EXPOSITION PARK MASTER PLAN

FINAL SUBSEQUENT ENVIRONMENTAL IMPACT REPORT (EIR)
TO THE LOS ANGELES MEMORIAL COLISEUM RENOVATION PROJECT EIR
(STATE CLEARINGHOUSE No. 1990011065)

SEPTEMBER 21, 2020

FIGURE 1.1.1-1
 Property Owners and Operators at Exposition Park

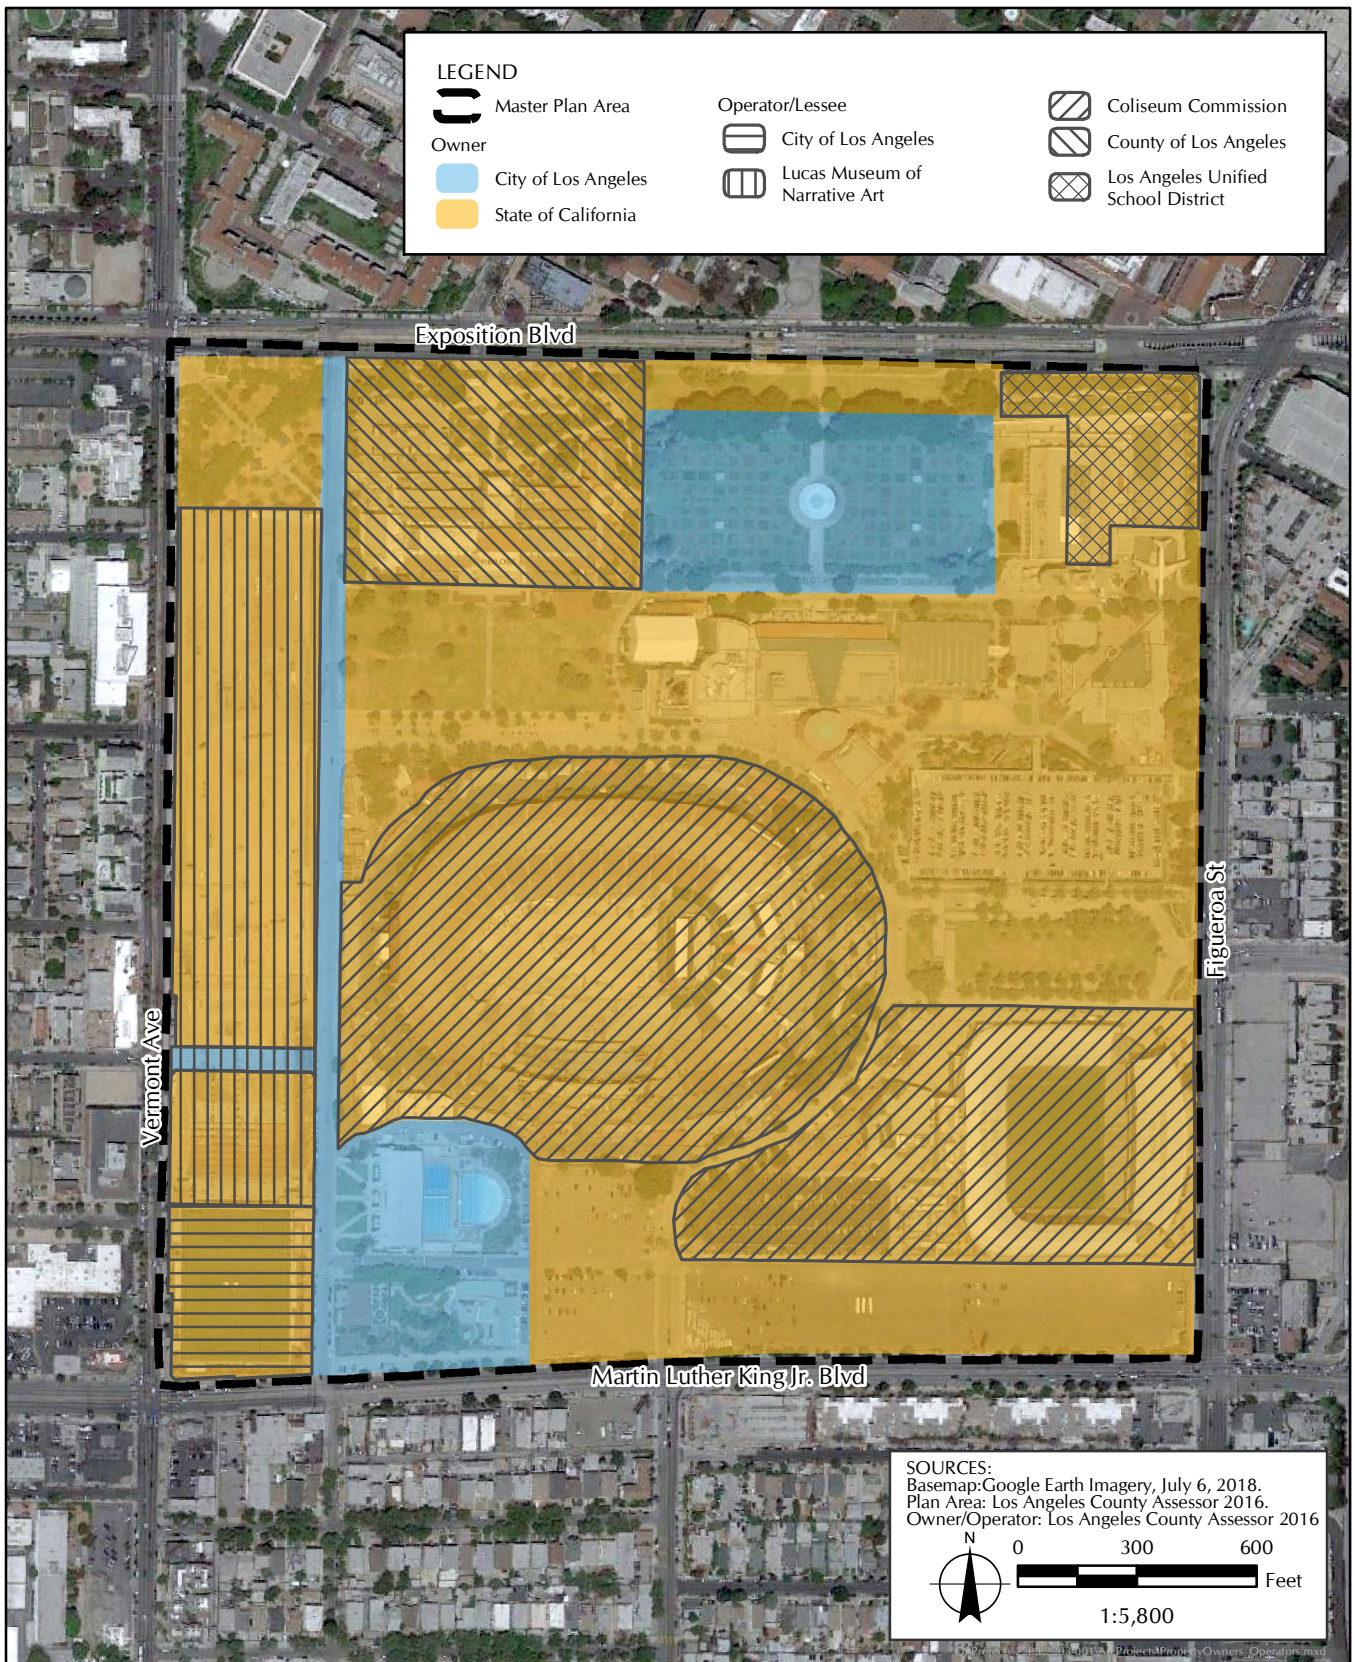
Figure 1.1.1-1, *Property Owners and Operators at Exposition Park*, has been revised to show that Soboroff Field is on State-owned land that is leased to the City of Los Angeles.

FIGURE 2.3-1
 Public Transit in Project Vicinity

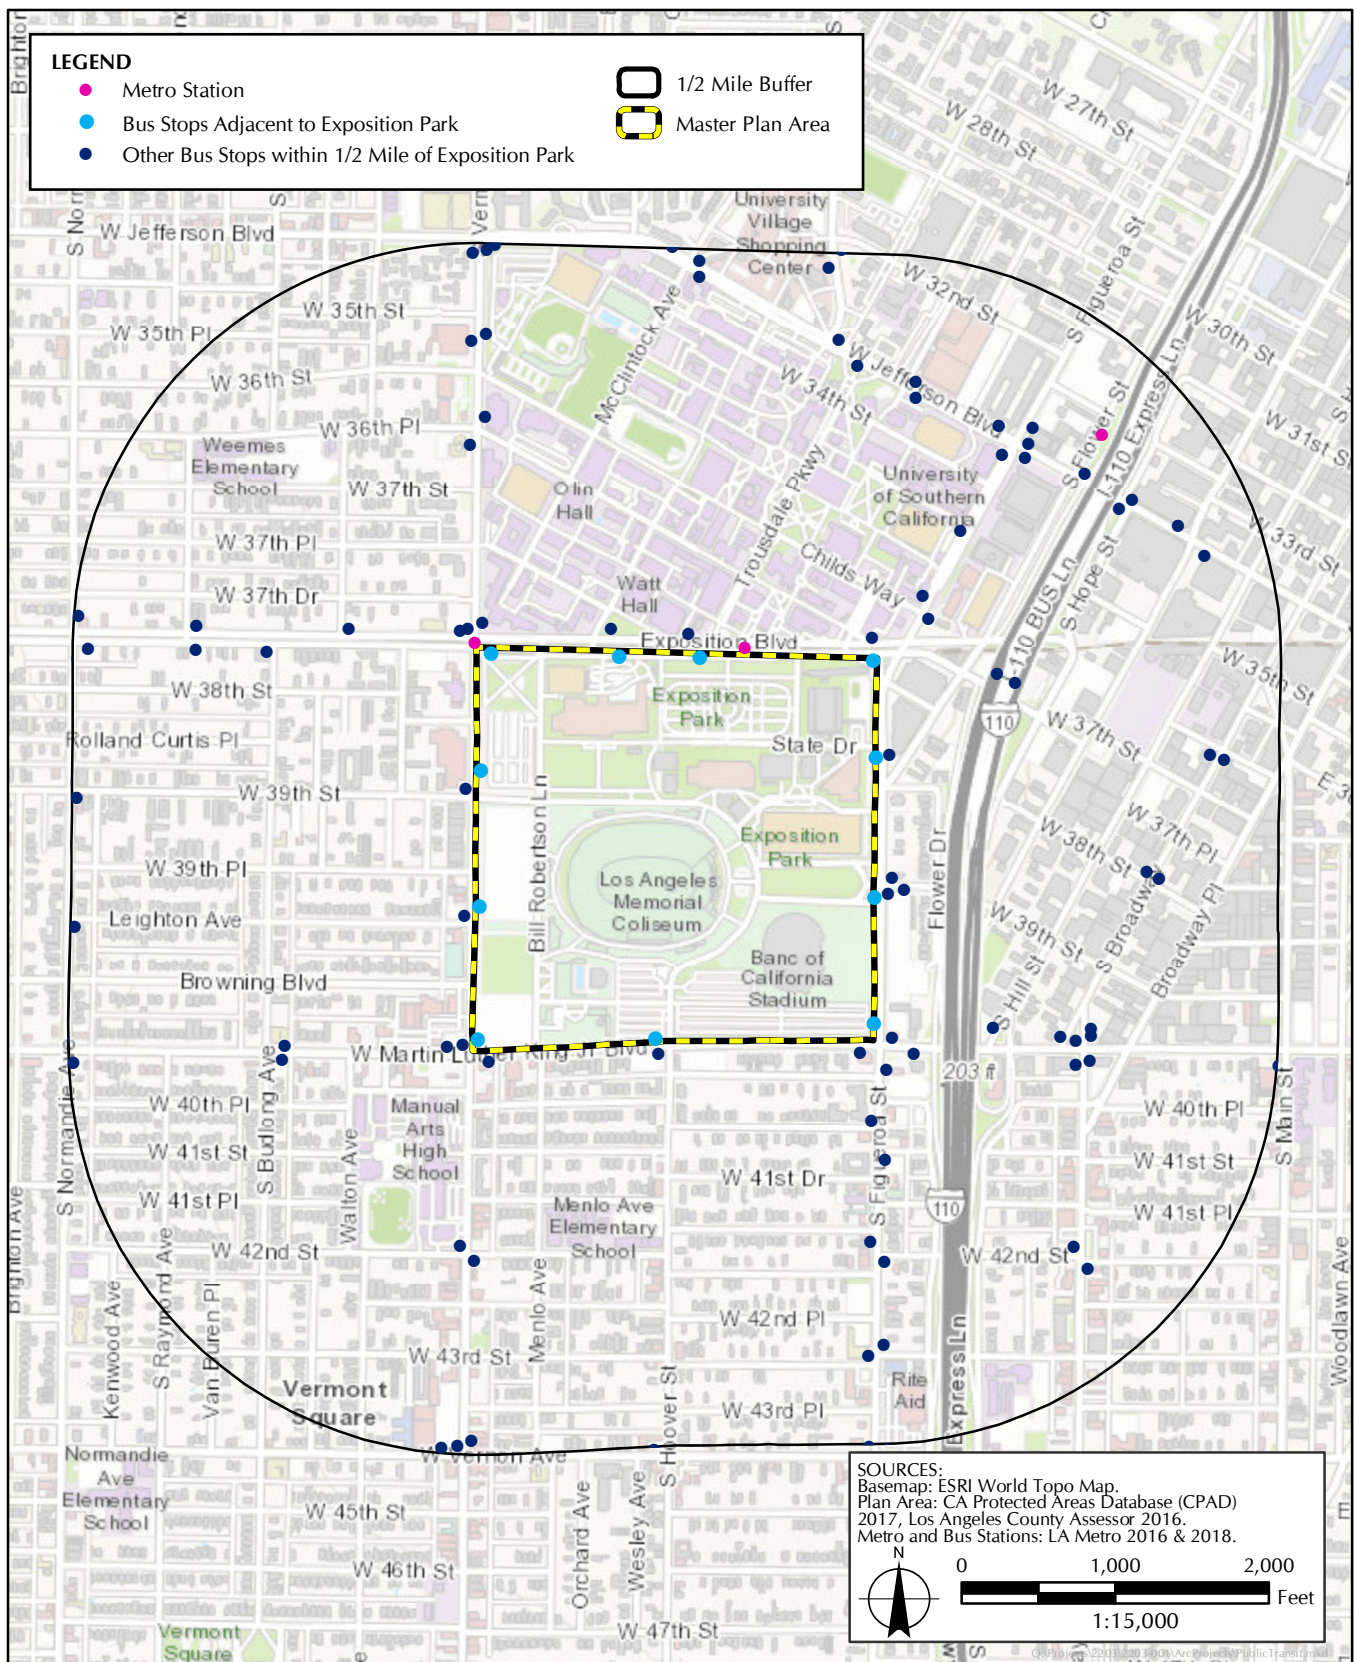
Page 2-4: Figure 2.3-1, *Public Transit in Project Vicinity*, has been revised to provide further detail regarding bus stops. These changes are described in the revisions to Chapter 2, *Project Description*, and Section 3.9, *Transportation*.
